**FSD Connects with the Construction Industry**  
**to Speed up Building Plan Processing and Acceptance Inspection of FSI**

**FSD connects with the  
Construction Industry to speed up  
Building Plan Processing and  
Acceptance Inspection of FSI**

**24.11.2017**

# Samples of Recent GBP Submissions for Sharing

# Omission of window / compartment calculations

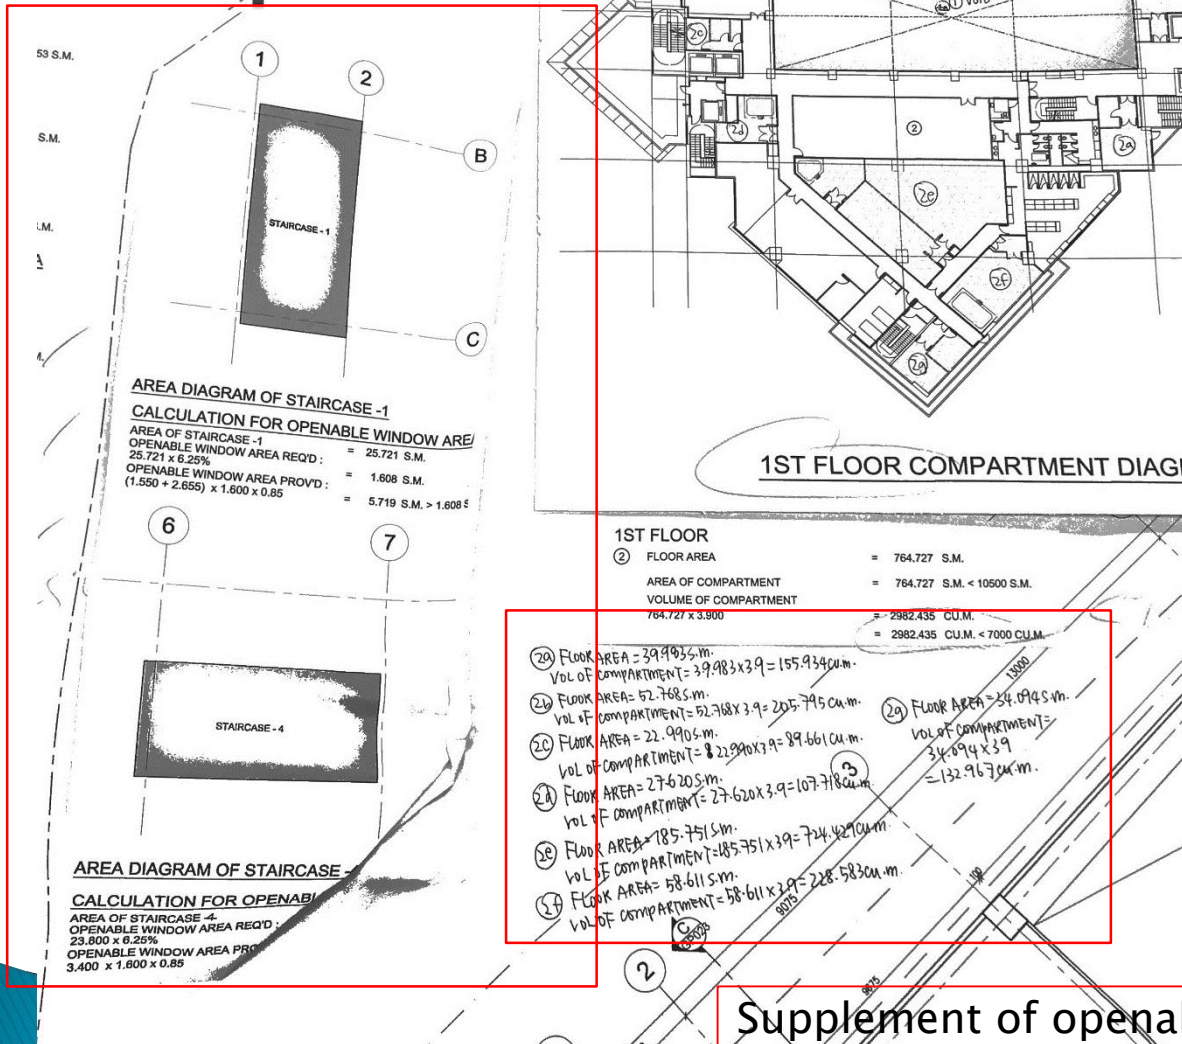
Supplement of openable windows and compartment calculation during plan amendment

# Fire Service Notes not tally with the building use

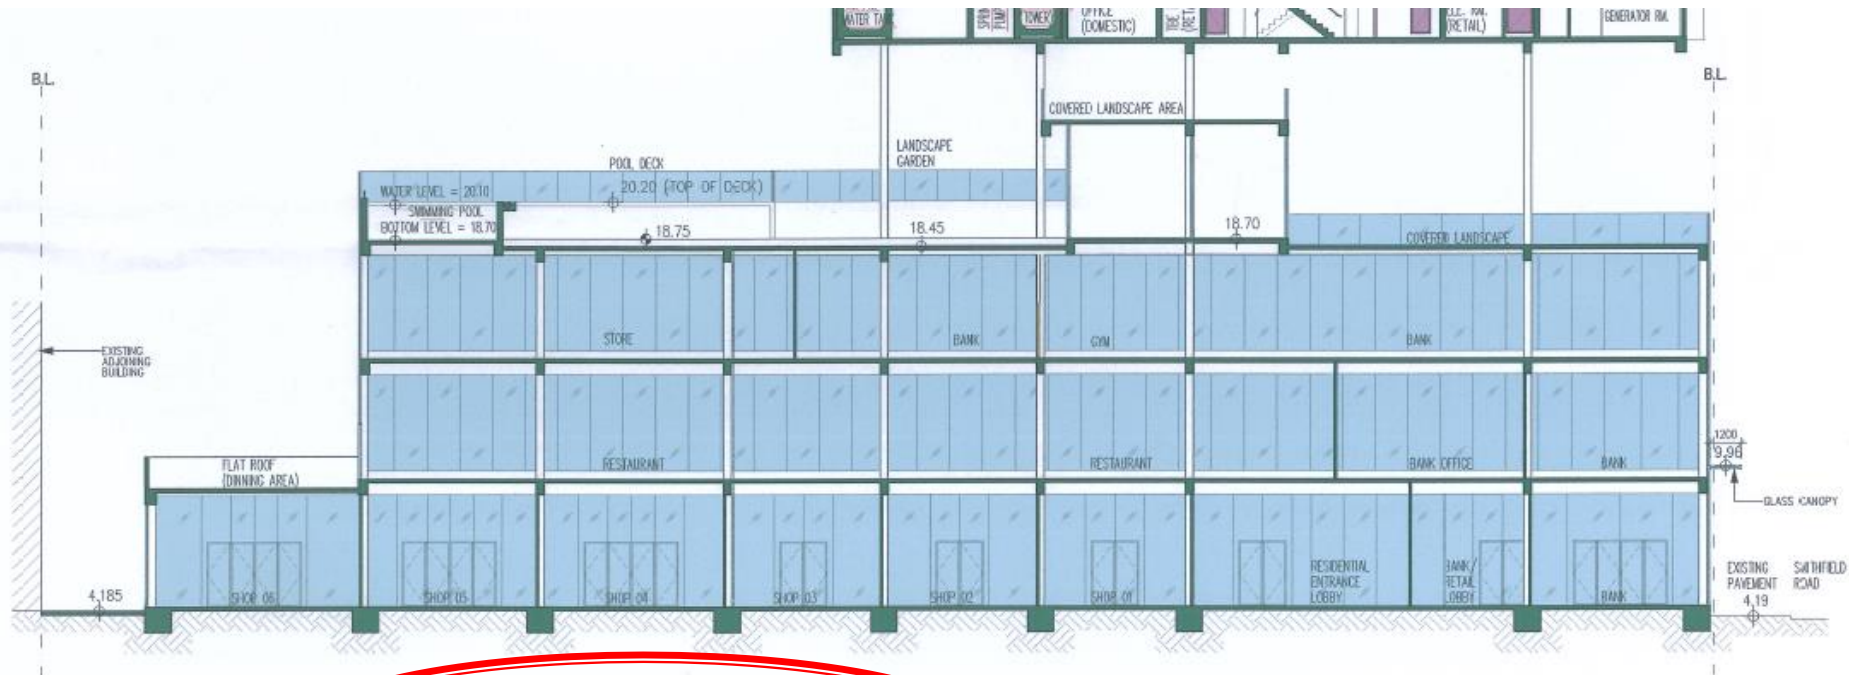
No Basement!!!

STOREY	COMPARTMENT	LOCATION / USE	U.F.
		<b>No Cinema!!!</b>	
TOWER (TYPICAL)	-	ALL FLAT UNITS (LARGEST TYPICAL FLOOR)	
3/F	-	MUSIC ROOM COMPUTER ROOM GYM POOL DECK SWIMMING POOL	
2/F	C	BANK OFFICE ARCADE BANK STORE	
1/F	B	BANK BANK OFFICE ARCADE RESTAURANT KIT FLAT ROOF (DINNING AREA)	
G/F	A	BANK SHOP 01 SHOP 02 SHOP 03 SHOP 04 SHOP 05 SHOP 06

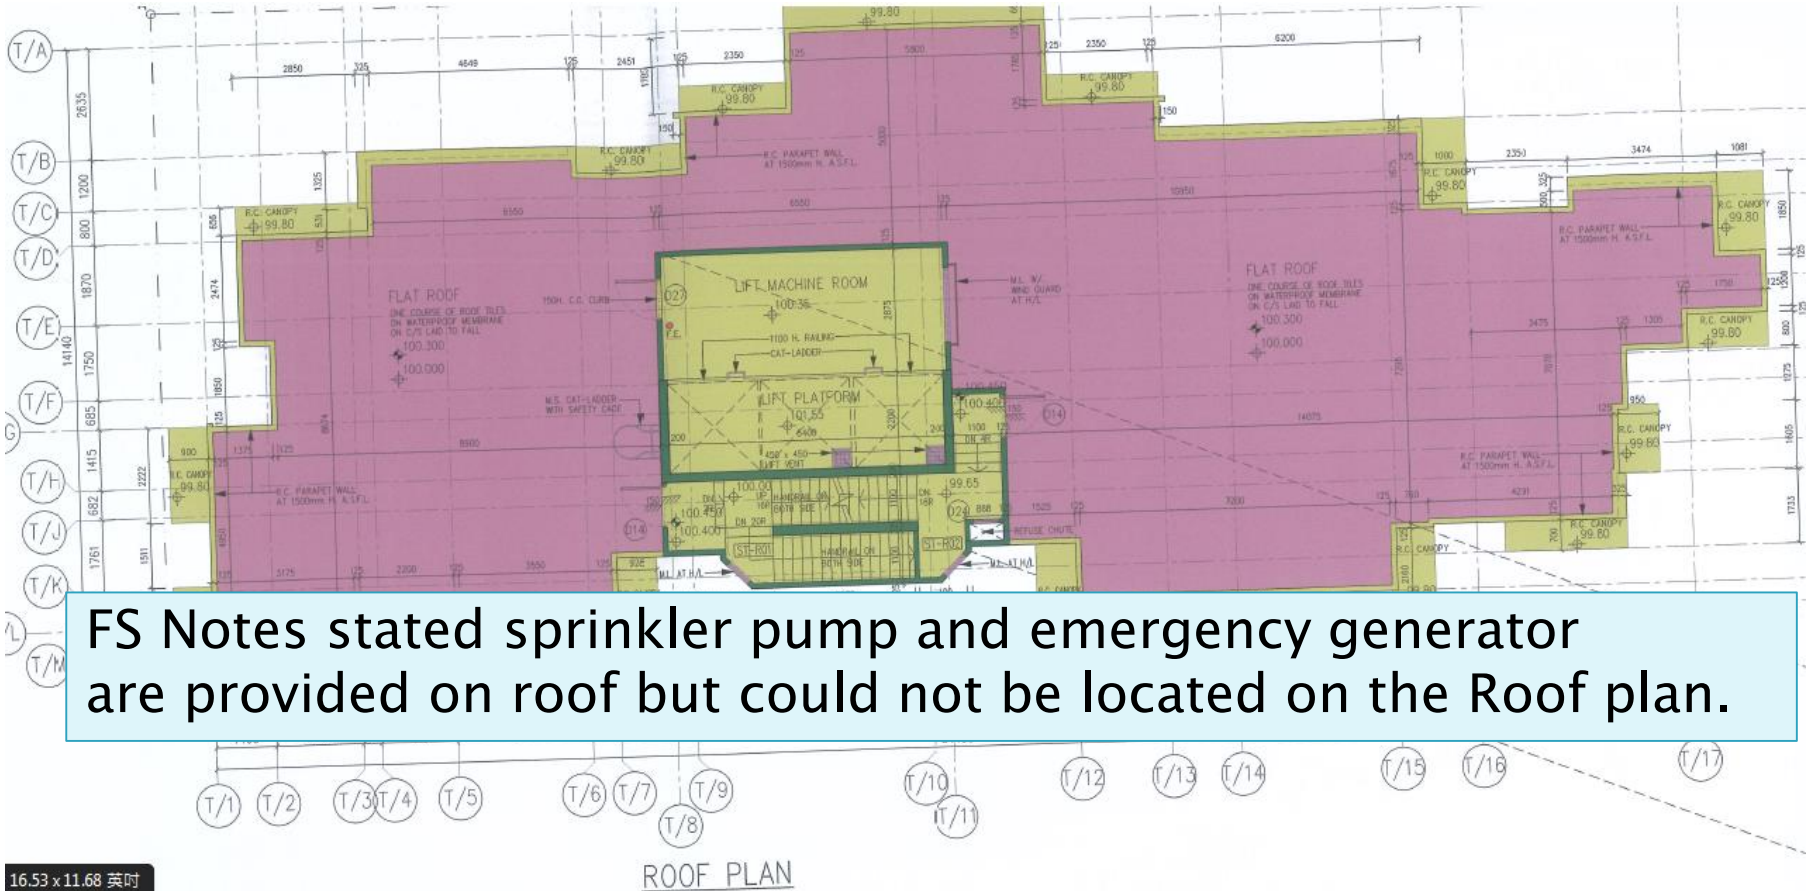
Refuge areas stated on FS notes but no Refuge Floor on plan!!!

# Re-submission required

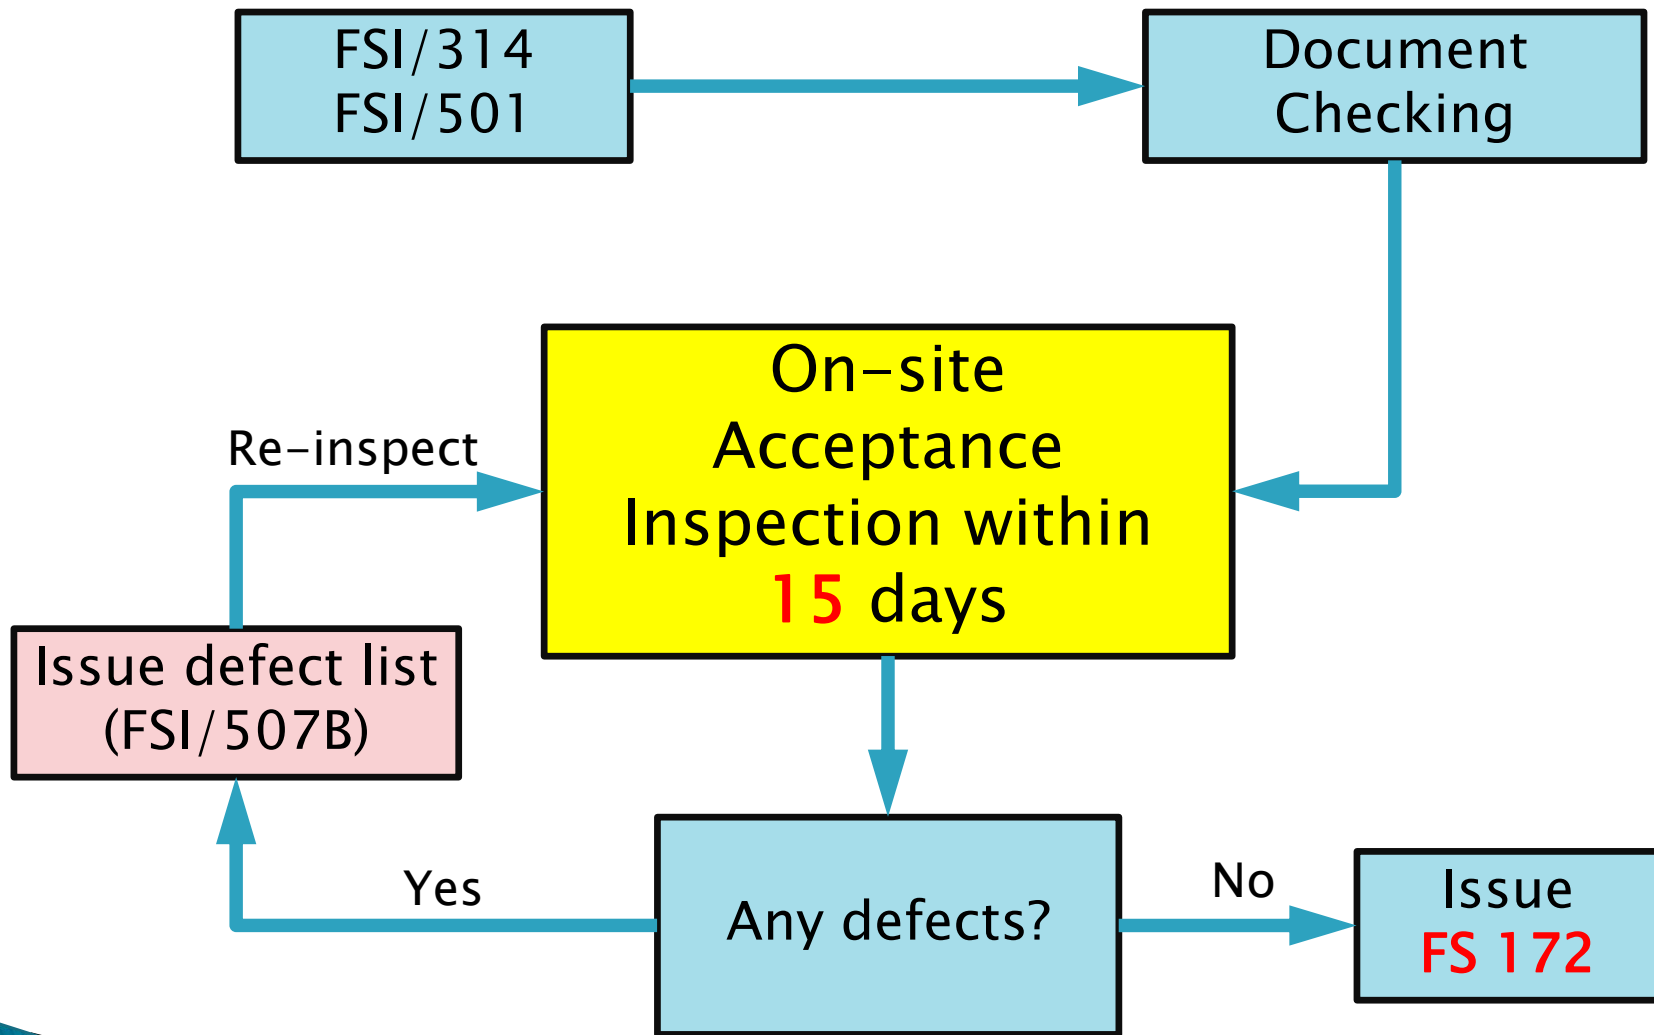
A series of uncorrectable irregularities, plan rejected.

- (ix) The set of FS inlet near Hung To Road shall be relocated to a prominent position on the exterior of the building;

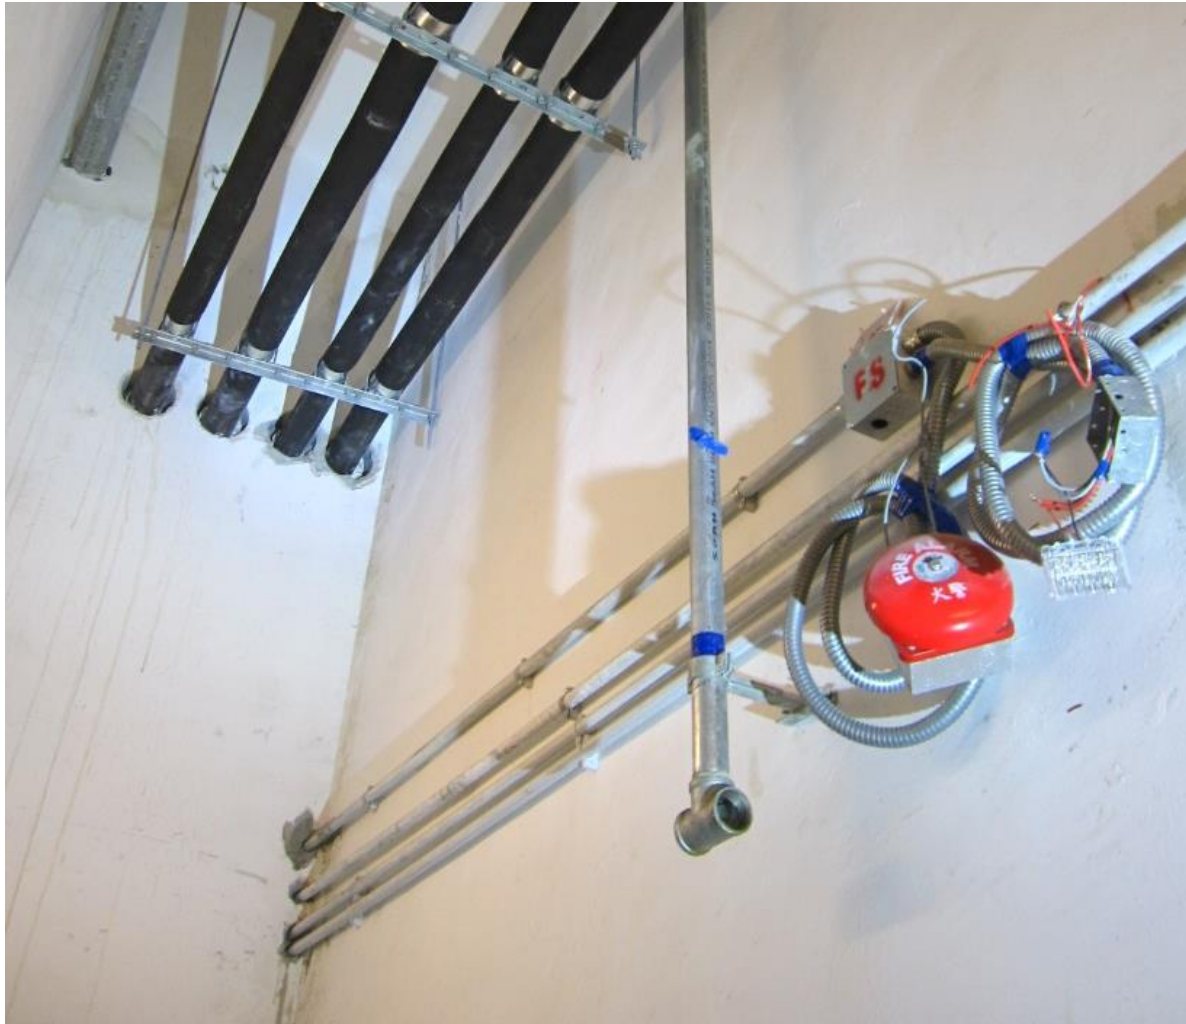
**✘ Unavailable secondary power supply for FSIs and incomplete installation of emergency generator**

**x Incomplete installation of smoke detectors**

**x** Incomplete installation of audio/visual alarms system

**x Incomplete Installation of FSIs**

**x** Improper installation of FSIs

**x** Improper installation of emergency lighting
